97.6 PHY Link Synchronization

Figure 97-mm --- SEND_S PN sequence generator by linear feedback shift registers S_n

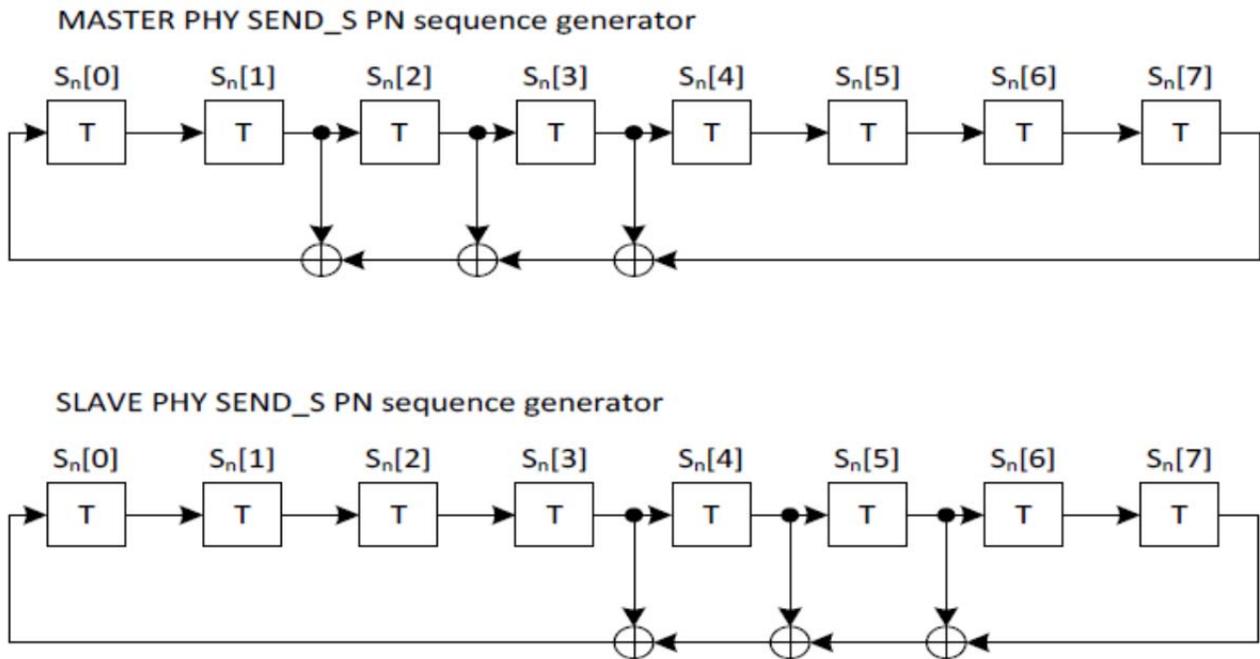
An implementation of MASTER and SLAVE PHY SEND_S PN sequence generators by linear-feedback shift registers is shown in Figure 97-mm. The bits stored in the shift register delay line at time n are denoted by $S_n[7:0]$. At each symbol period, the shift register is advanced by one bit, and one new bit represented by $S_n[0]$ is generated. The PN sequence generator shall be reset upon execution of the Auto-negotiation Reset function, or whenever sync_tx_mode value changes to SEND_S from SEND_Z. If the PN sequence generator reset is executed, all bits of the 8-bit shift register may be set to arbitrary values except for all zeros.
